STAFF REPORT: MAY 14, 2025 REGULAR MEETING

APPLICATION NUMBER: HDC2025-00157

ADDRESS: 150 W. BOSTON (a.k.a. BENJAMIN SIEGEL HOUSE)

SCOPE: ERECT BATHROOM/SHOWER POOL STRUCTURE (REVISION TO PREVIOUSLY APPROVED DESIGN)

2024 rendering - previous design.

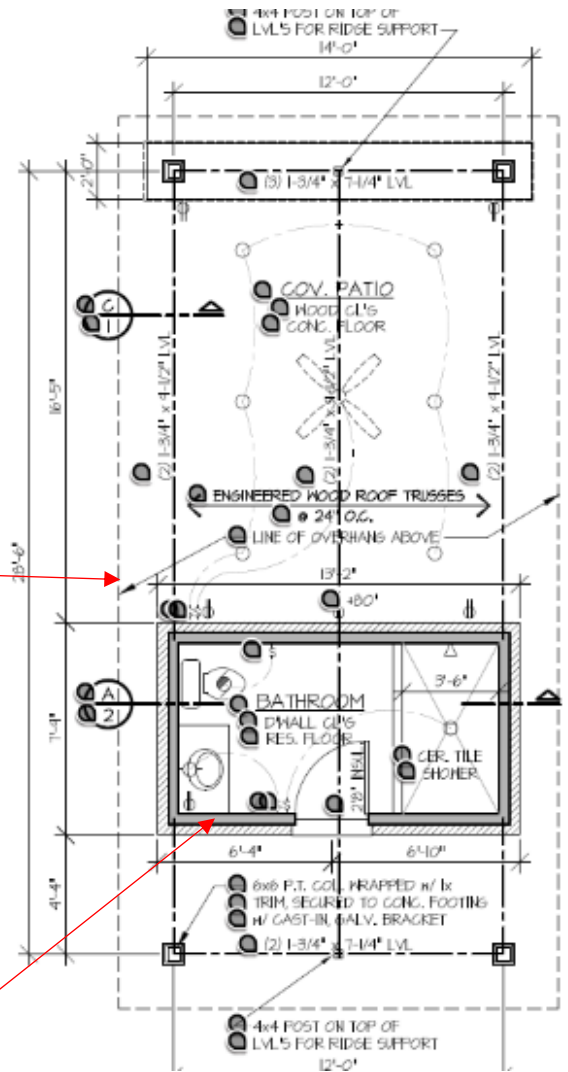
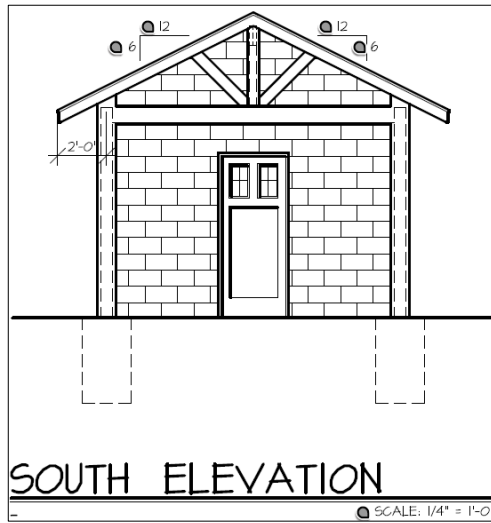
Current design and placement of the patio with bathroom enclosure. The extra length of the structure was accommodated by extending the structure to the end of the patio, as seen in the rendering below.

Applicant drawings. The width (approximately ¼ the length of the patio), its slight asymmetrical placement, and open space between each pair of corner columns, reduces the physical presence of this solid element. The stone veneer cladding will complement the house and surrounding landscape elements within the pool area.

Staff recommends that the proposed work will be appropriate according to the Secretary of the Interior's Standards for Rehabilitation and the Boston-Edison Historic District's Elements of Design.
